PRODUCT CHANGE NOTIFICATION 0004

Issue Date: 08/24/2022

Due to supply chain shortages, TCI is temporarily replacing field wiring connections in selected passive harmonic filters. Please reference *Part Numbers Affected* and *Product Identification* below.

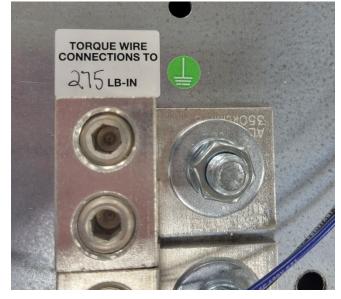
Replacement with same performance

Some information provided on documents such as customer drawing and manual may differ from provided customer connection lugs. Wire range 350MC - 6Awg was maintained, but size of torque screw and torque was updated due to a shift in manufacturer. Previously required tool was [3/8 hex] with torque of 375 lb-in, the new terminals require tool [5/16 hex] with torque of 275 lb-in. Please refer to torque designator labels near/on customer connections when uncertain.
